Shandon Residents Association submission — Metrolink RO case number 314724
48 Shandon Park, Phibsboro, Dublin 7 D07FX40

Ref: ABP-314724-22

Railway (MetroLink - Estuary to Charlemont via Dublin Airport) Order [2022]

Briefing note on issues at Glasnevin Station
(Coke Oven Cottages, Shandon Mill, Royal Canal Cleanup Group & PVTT)

Figure 6.4 Proposed southern access to the temporary bridge

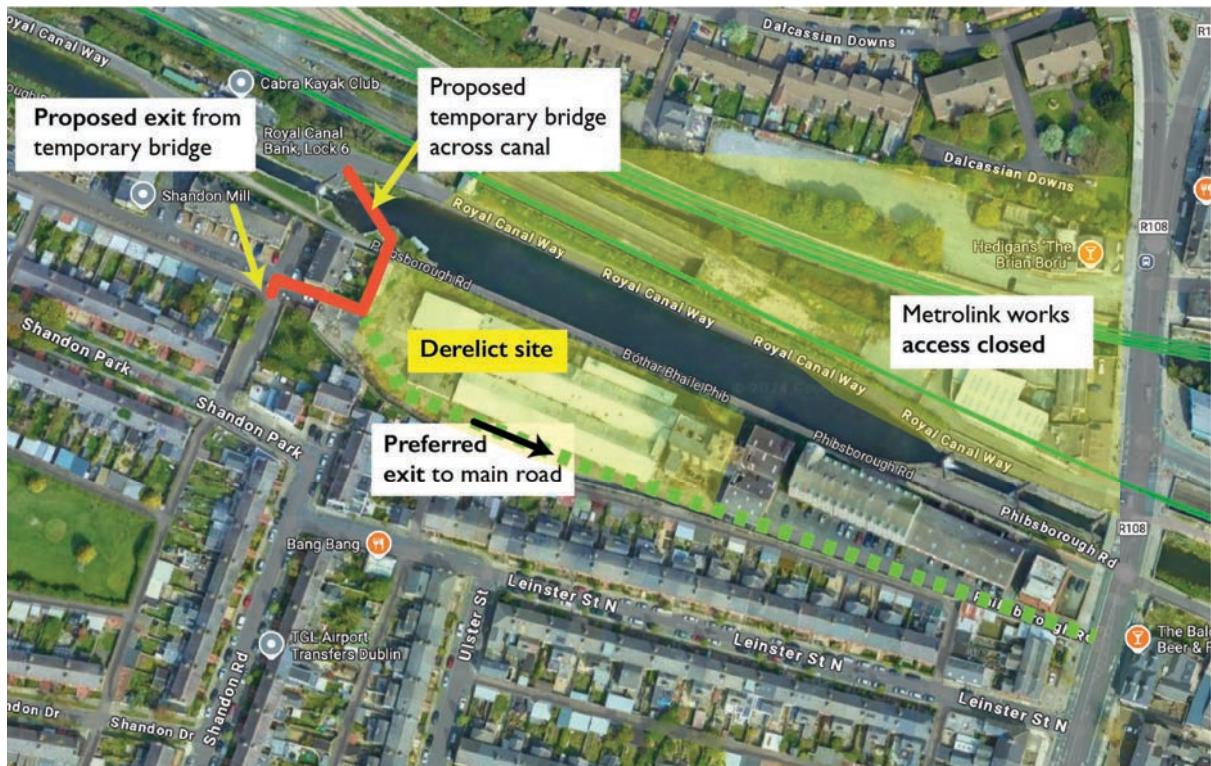
Our question: Will temp exit road now go through the Crossguns site rather than via Shandon Park?

We have not been given any or any satisfactory reason why the temporary exit road cannot be routed through the Crossguns site rather than via Shandon Park, and it is disappointing not to find amongst the Additional Documents an explanation as to why this has been rejected by TII.

Our recollection, as recorded in our own contemporaneous notes from the Hearing, is that the inspector [was interested to know why TII would not consider this alternative] and also that he queried the proposed gradient of the bridge. Regarding the design of the temporary bridge (especially the gradient) and we asked the question in the Oral Hearing and included it in the questions emailed on September; the response from TII for this query was: *Whilst this subject was discussed at the Oral Hearing, no new drawing was requested nor produced for this bridge. TII confirms that the bridge will be designed to the relevant technical standards.*

There was no satisfactory answer during the Hearing or in the Additional OH Documents, or since, as to why the temporary access could not be routed through the derelict industrial site instead of through Shandon Mills. This would not preclude future development when the station is finished. There is also a remaining concern that the temporary bridge will be difficult to navigate for the size of the vehicles required to use it on the tight turns and steep gradient (as can be seen from applicant's proposal on previous page).

TII/Metrolink response: No, as shown by the RO application, the temporary exit road will be through Shandon Park.

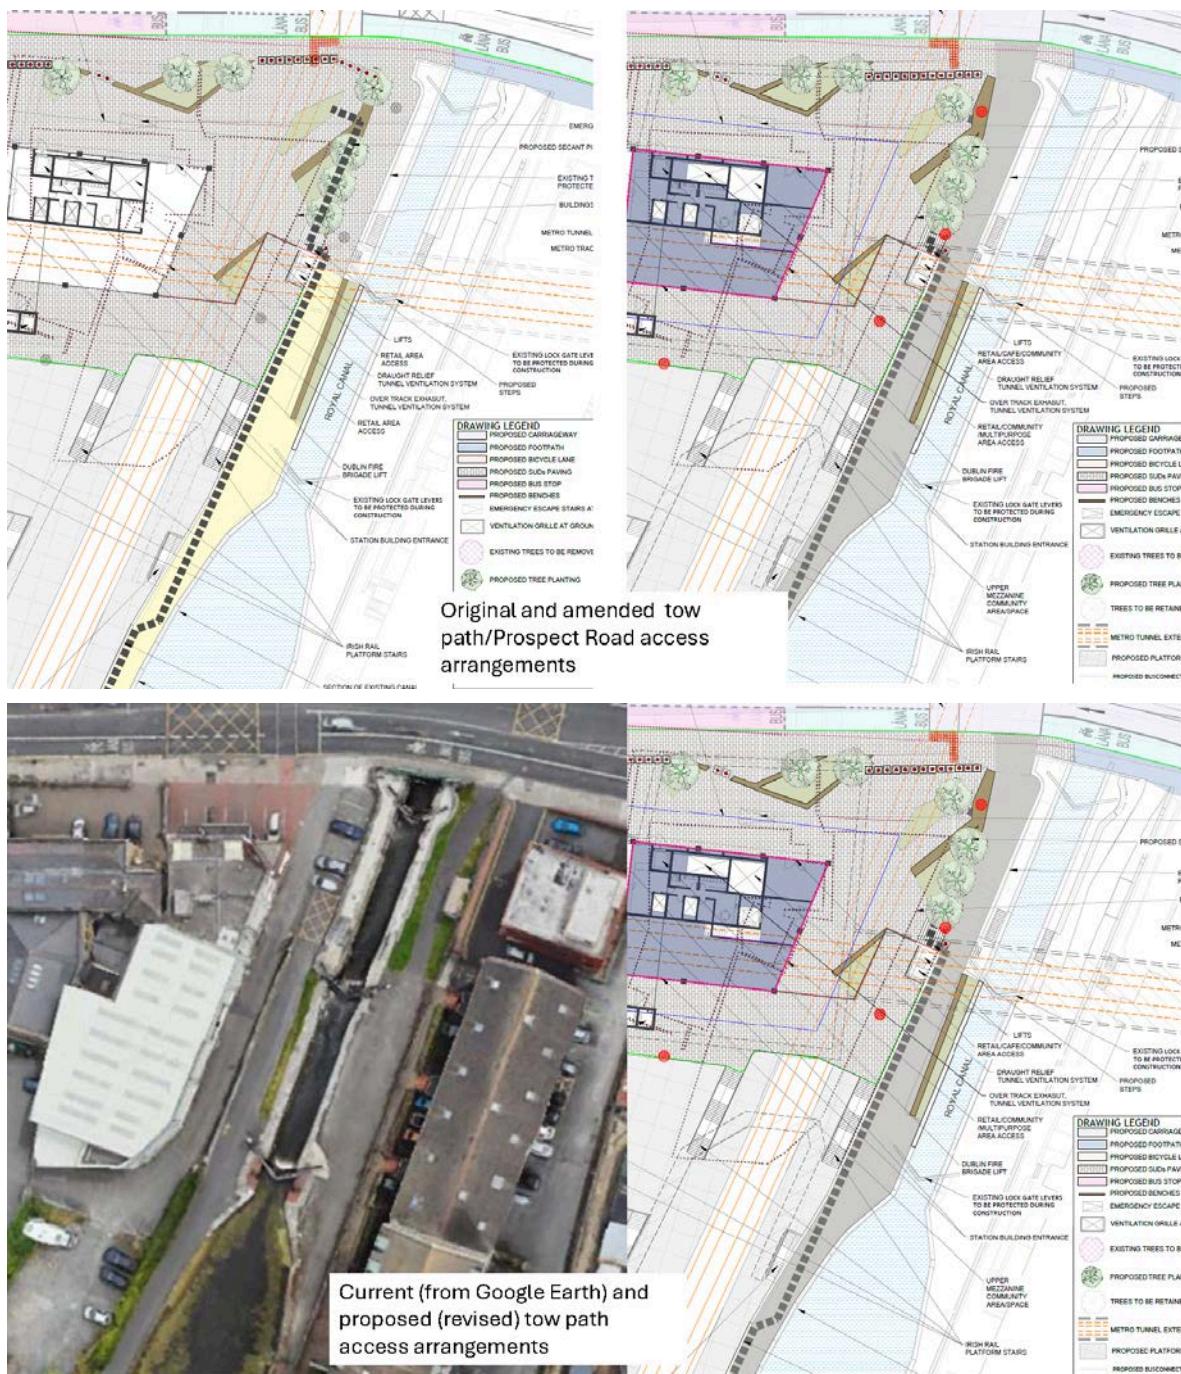
Our Question: Glasnevin Station Plaza design surface not accounting for heavy goods traffic (Inspector said proposed surface would be crushed after a few Waterways trucks, for example).

From the below, if it has been widened, it isn't very obvious from the amended drawing:

Response: *Whilst we do not recall the comment about the trucks specifically, TII can confirm that all surfaces will be designed to the relevant technical standards taking account of the traffic that will be using the route. Drawing ML1-JAI-SRD-ROUT_XX-DR-Y-02057 shows separation between the station concourse (vehicles excluded by bollards, planting boxes etc.) and the entrance to the tow path [and different surfaces indicated for both accordingly].*

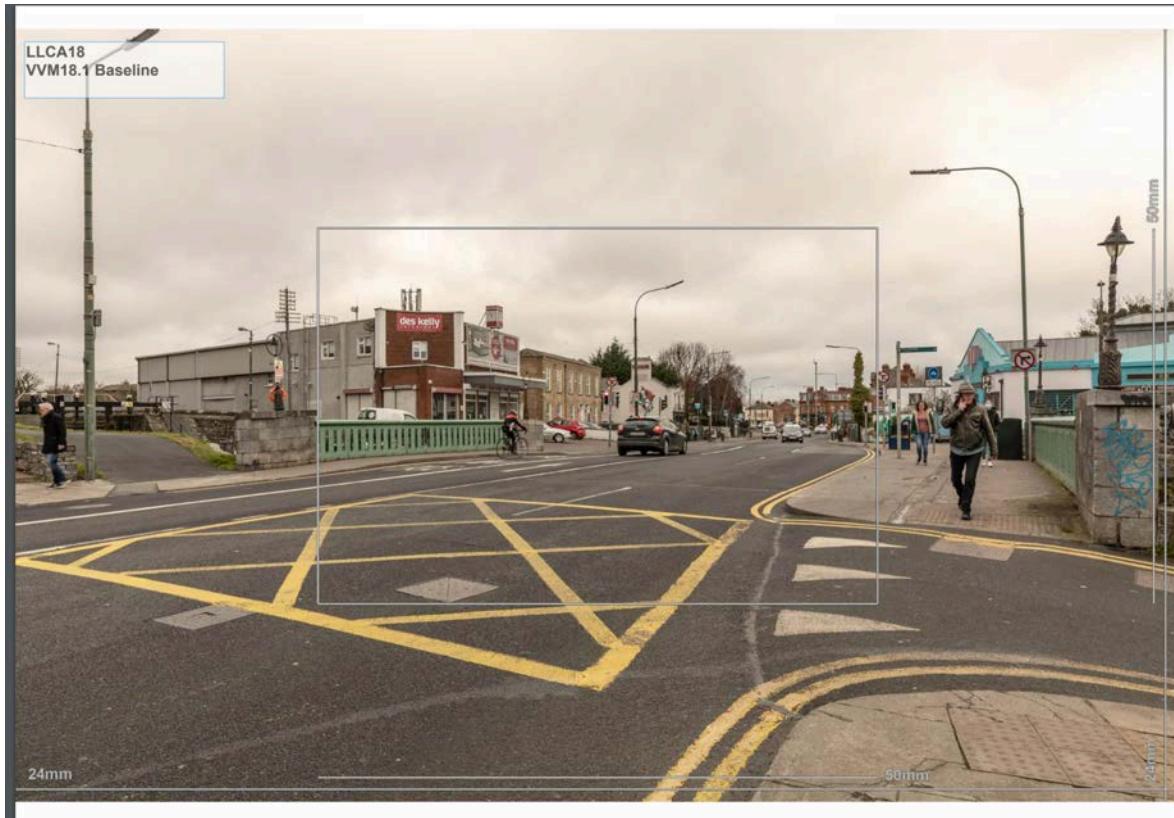
The updated photomontages ([Day 21, item 15](#)) and original photomontages ([Appendix A 27.1 to EIAR](#)) for Glasnevin don't show any discernible differences between the montage showing the SE corner of the station (page 192 of A27.1 and page 123 of the updated photomontages despite the changes to the layout and details shown on the amended drawing .

views from the east and north (pages 194 and 196 in the original proposal and 126 and 128 in the updated version) – again differences between the versions are very difficult to spot.

It is difficult to discern the tow path access from the renderings as the camera angle is unhelpful.

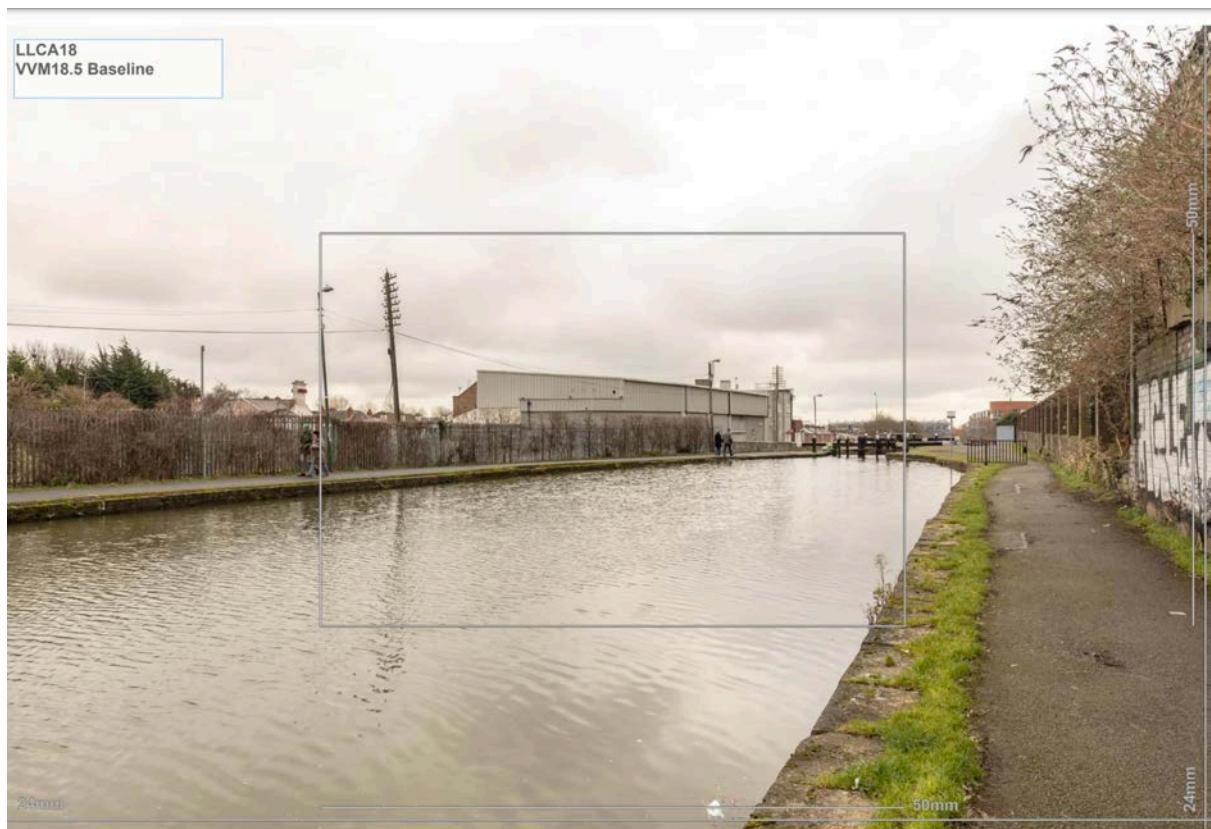
We would still urge considerations to be given to greening alongside and there seem to be contradictory visuals available between the plans showing planters and the renderings (photomontages and artists' impressions) that don't.

As you can see, this above approach severs the idea of a habitat corridor along the canal.
